**APPROVED**

By BOCC 9-6-18 at 11:25 am, Feb 21, 2019

Nevada Northwest LLC Specific Plan Amendment #2

On September 18, 2017, the Douglas County Board of Commissioners approved land use amendments to property located in the South Commercial Planning Area portion of the Nevada Northwest Specific Plan. This 3<sup>rd</sup> amendment to the Nevada Northwest Specific Plan is an update in response to these land use changes. This update to the Nevada Northwest Specific Plan (Amendment #3) only affects land identified in Figure B-1, an area situated within the South Commercial Planning Area boundaries.

1877-015 **FIGURE H-2** 06/11/18

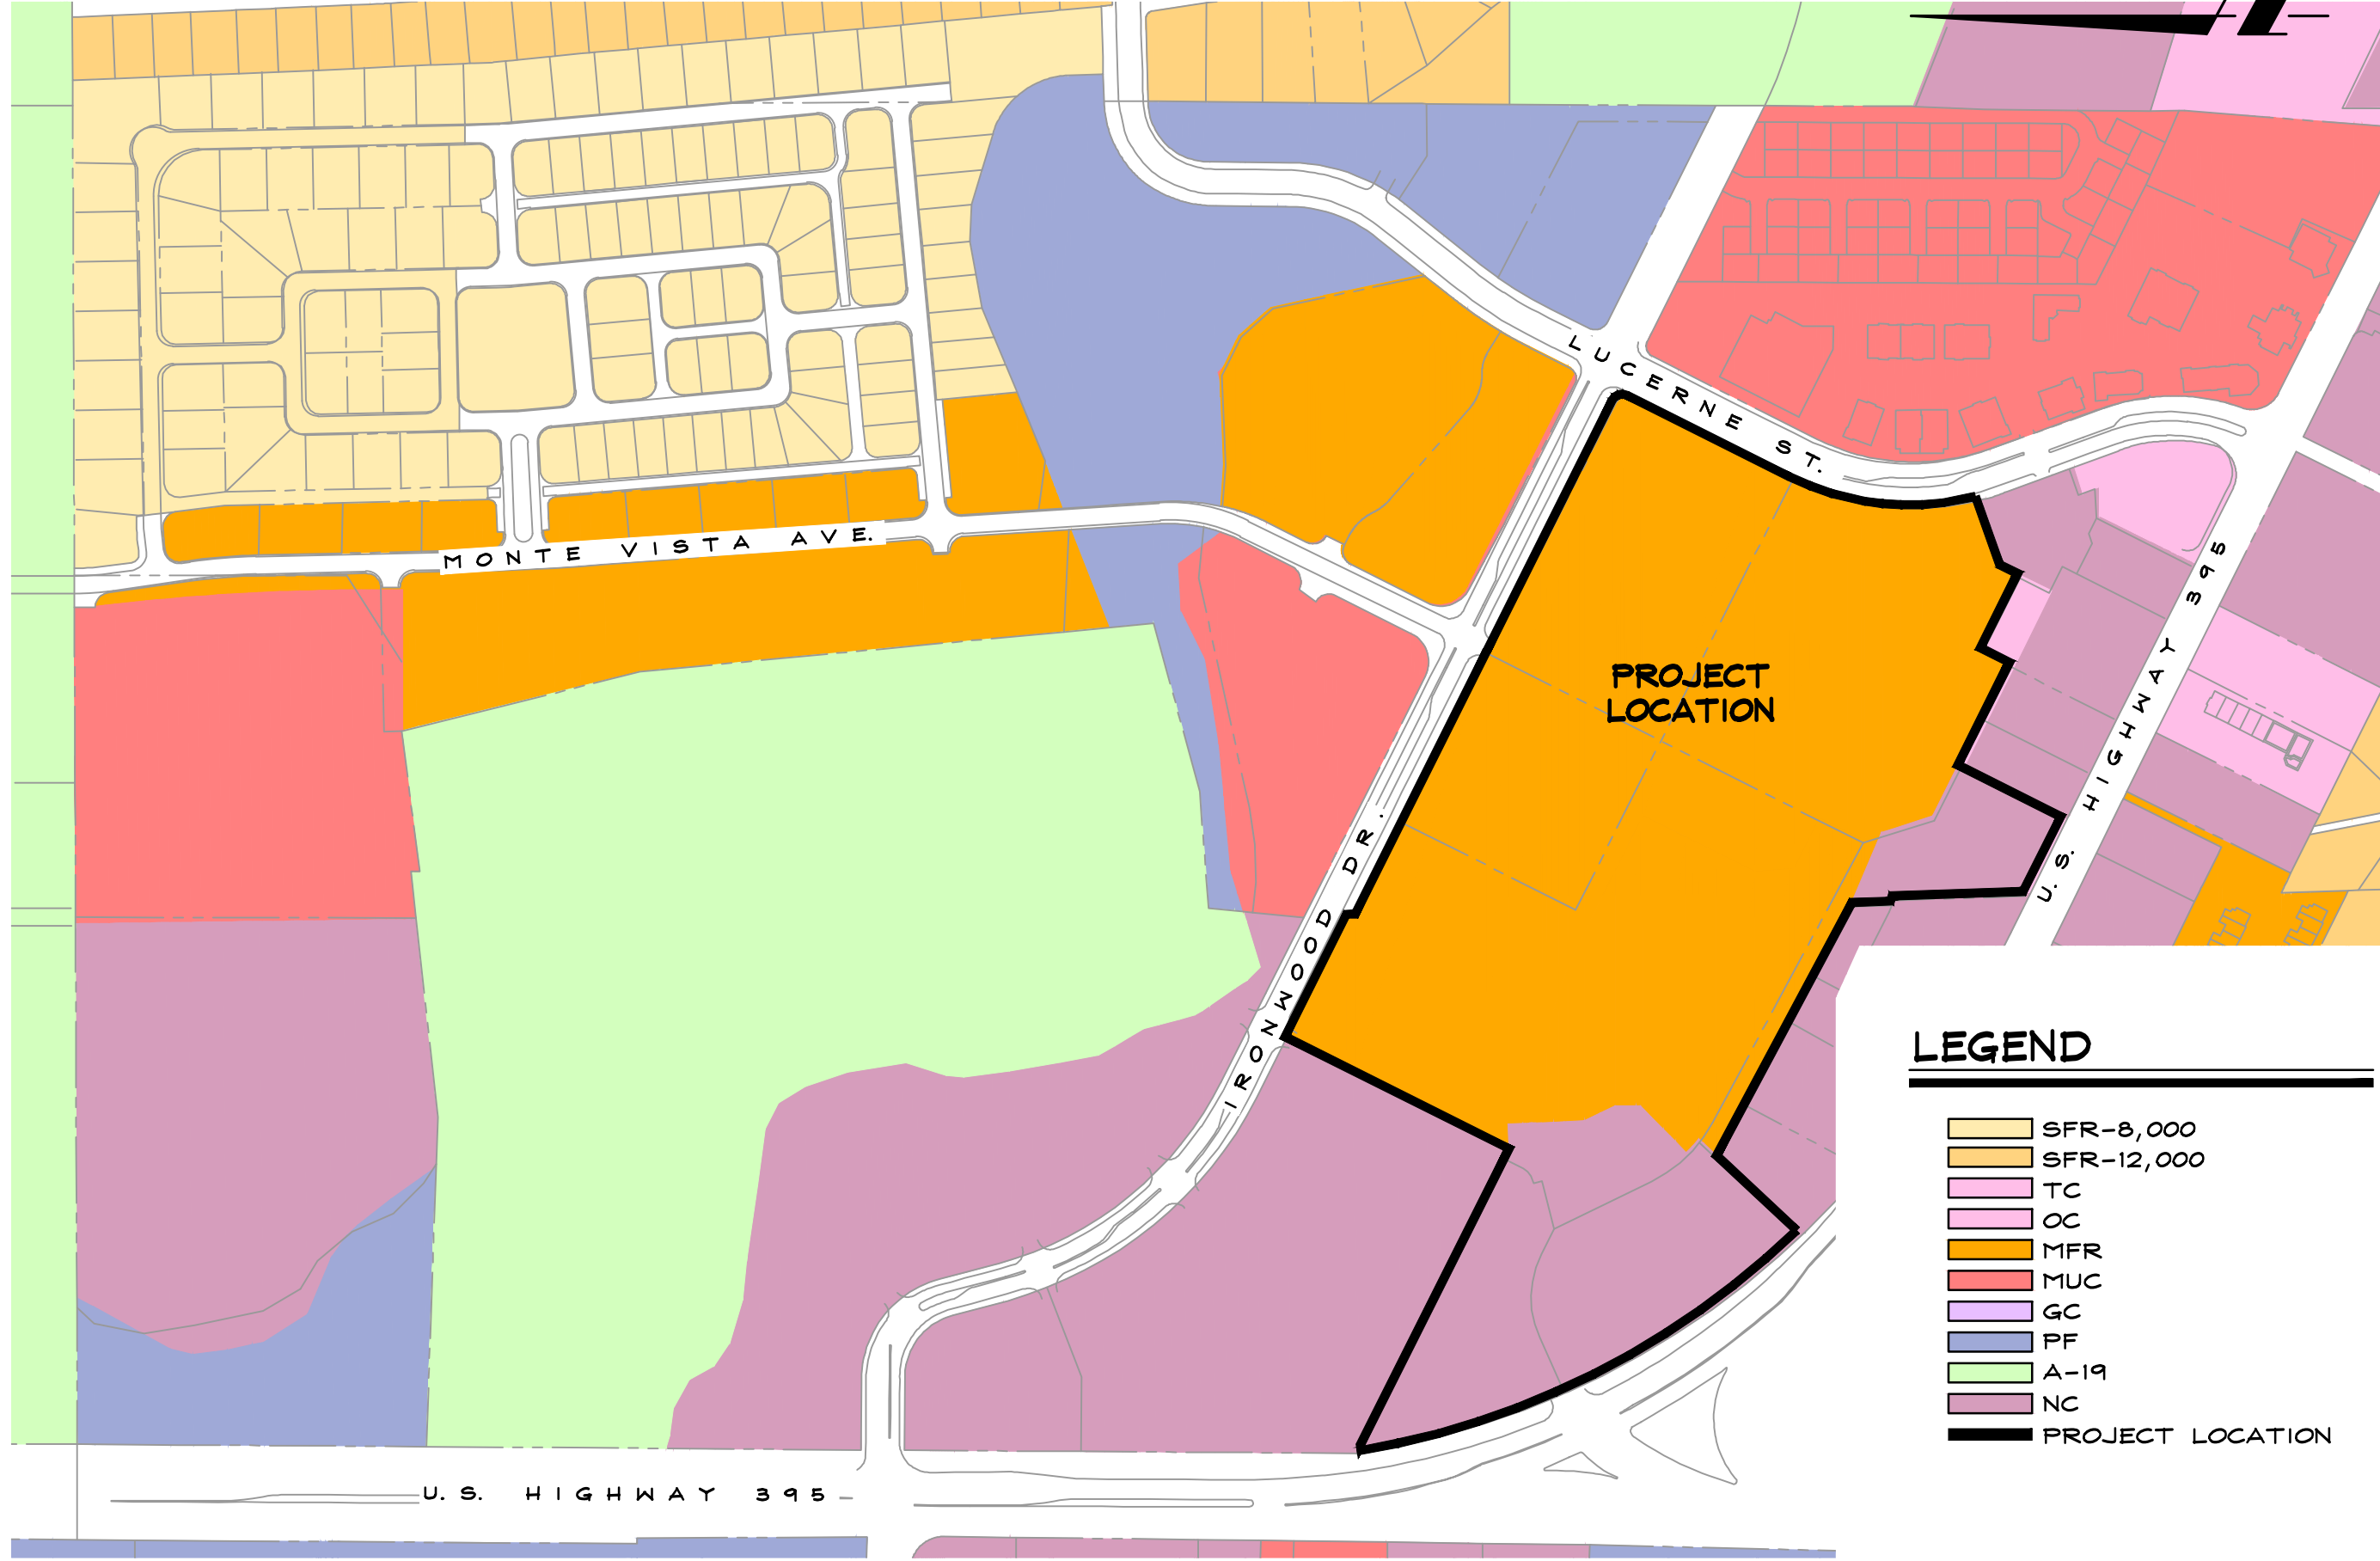
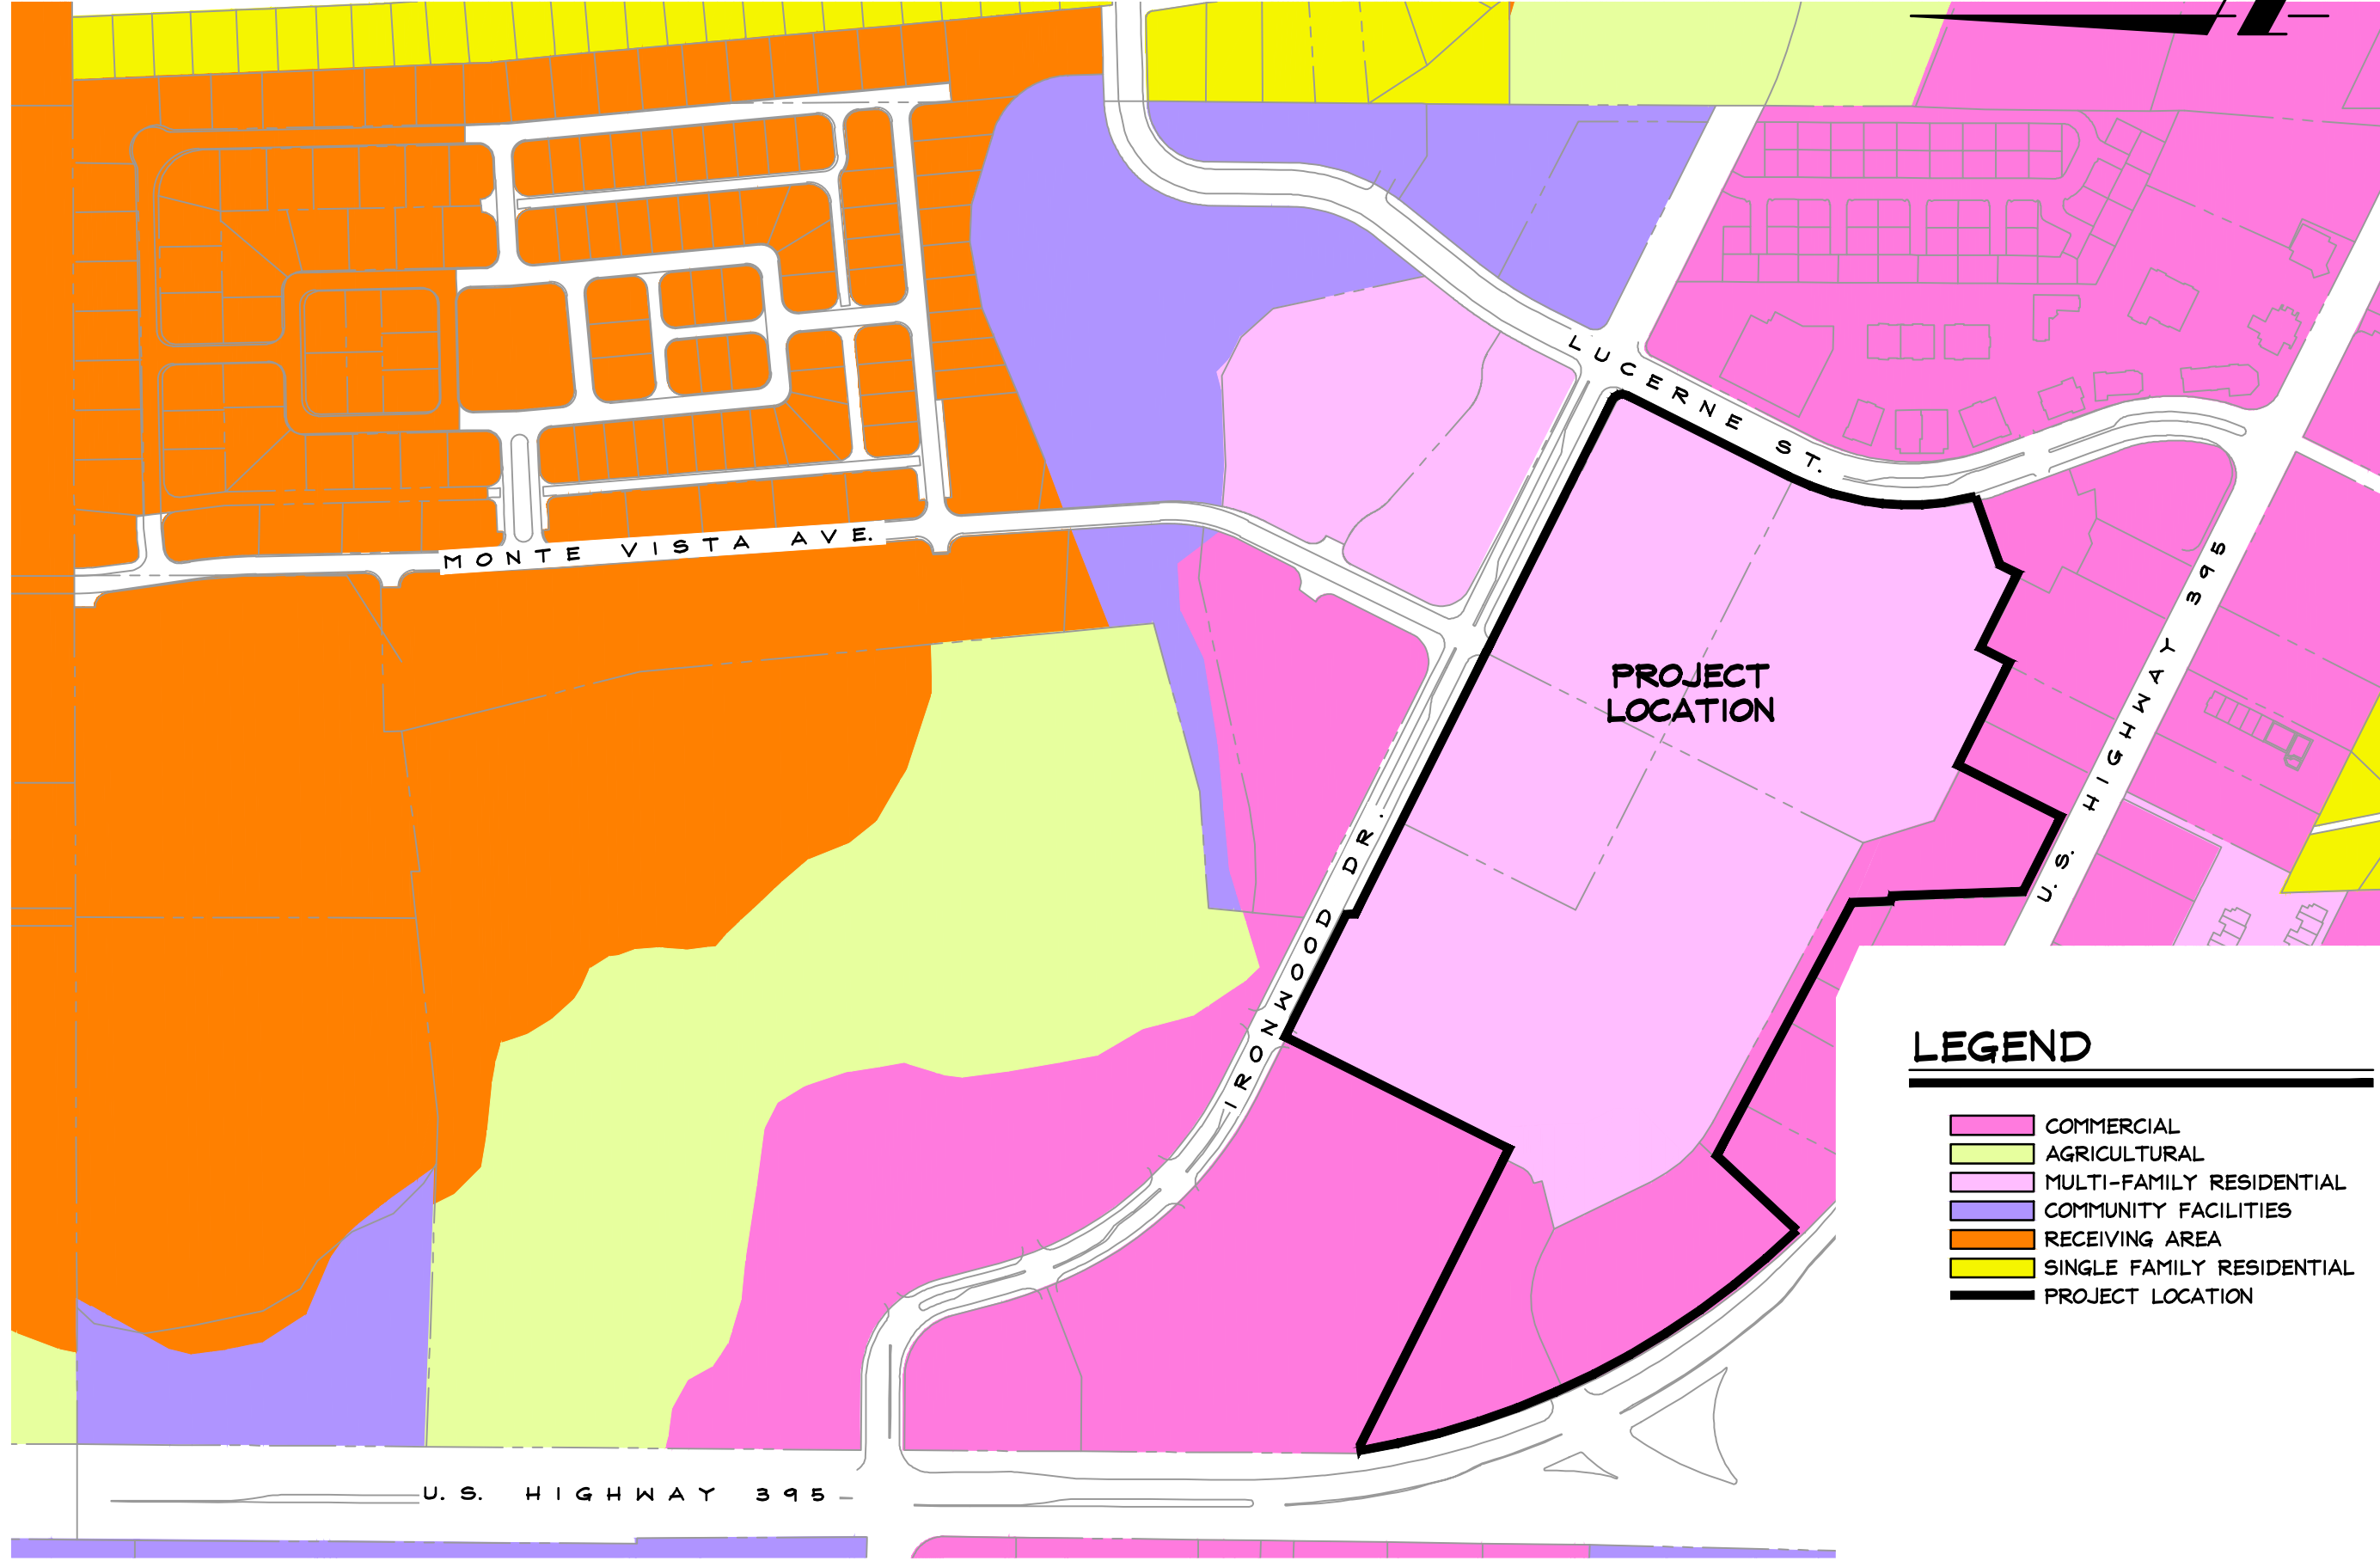
~~Exhibit 2~~ Figures H-2 and H-3, entitled “Existing Zoning Map 2017” and “Proposed Zoning Map 2018,” graphically depicts the existing zoning and proposed zoning of the Nevada Northwest LLC Specific Plan South Commercial Planning area site and the surrounding area.
